Access Compliance Report

Public Rights-of-Way

Intersection ID: 29122	Main Street: CANDLE_LEAF_CT	Cross Street: CRISP_WOOD_LN	Location: NE
ADA ID: 0AC49F4DED1C	Ramp Type: BlendTrans1	Initial Pass/Fail: Pass	Overall Compliance: No
		Severity Score: 12.5

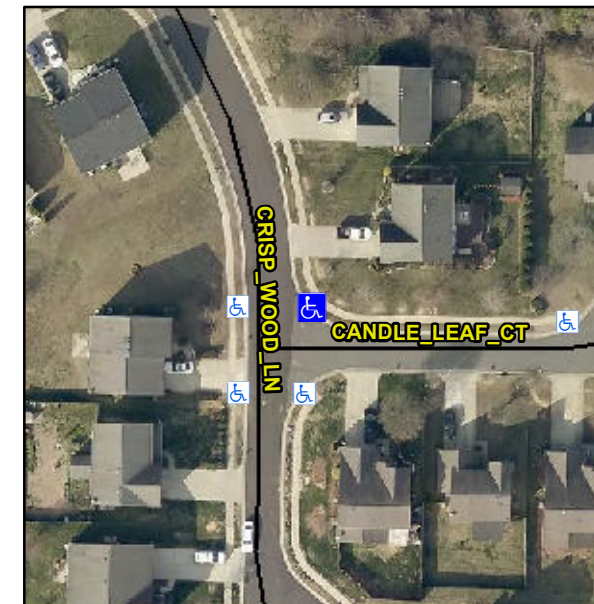
Not Found, R304.2.2-Perp, R304.3.2-Para, R305.1.4, R302.7.2, R304.5.4

Compliance	Description	Data	Compliance	Description	Data
N/A	Ramp Length (in)	47.0	Yes	BlendTrans Slope (%)	3.7
Yes	Ramp Width (in)	48.0	Yes	BlendTrans XSlope (%)	0.4
N/A	Flare Type LT	Sloped	N/A	Flare Type RT	Sloped
N/A	Flare Slope LT (%)	4.7	N/A	Flare Slope RT (%)	4.2
N/A	Flare Traversable LT?	No	N/A	Flare Traversable RT?	No
Yes	Landing Length (in)	48.0	Yes	DWS Provided?	Yes
Yes	Landing Width (in)	48.0	Yes	DWS Contrast?	Yes
No	Landing Slope (%)	3.0	No	DWS Length (in)	23.0
Yes	Landing X Slope (%)	0.5	Yes	DWS Full Width?	Yes
N/A	Landing Curb? (Y/N)	No	Yes	DWS Offset (in)	2.0
N/A	Shared Landing?	No			
Yes	Gutter Ponding?	No	No	Gutter Slope (%)	6.1
No	Gutter Lip Ht (in)	0.3	Yes	Gutter X Slope (%)	1.2
N/A	Painted X Walk1?	No	N/A	Painted X Walk2?	No
	X Walk 1 Direction	To W		X Walk 2 Direction	To S
	X Walk 1 Width (in)	N/A		X Walk 2 Width (in)	N/A
	X Walk 1 Slope (%)	6.0		X Walk 2 Slope (%)	3.1
	X Walk 1 X Slope (%)	4.3		X Walk 2 X Slope (%)	4.6

N/A	Ramp inside XWalk1?	N/A	N/A	Ramp inside XWalk2?	N/A
	Road Slope (%)	1.0		Clear Space?	Yes
	Road X Slope (%)	5.8	N/A	Clear Space to XWalk (in)	N/A
Yes	Any Obstructions?	No	Yes	Storm Grate/Utility Hazard?	No
	Obstruction Type			Storm Grate/Utility Type	
		N/A			N/A
			Yes	Surface Condition? (G/P)	Good
			No	Curb Slope (%)	5.2

Remove & Replace Curb Ramp With Two New Directional Ramps or Equivalent. Remove & Replace Gutter.
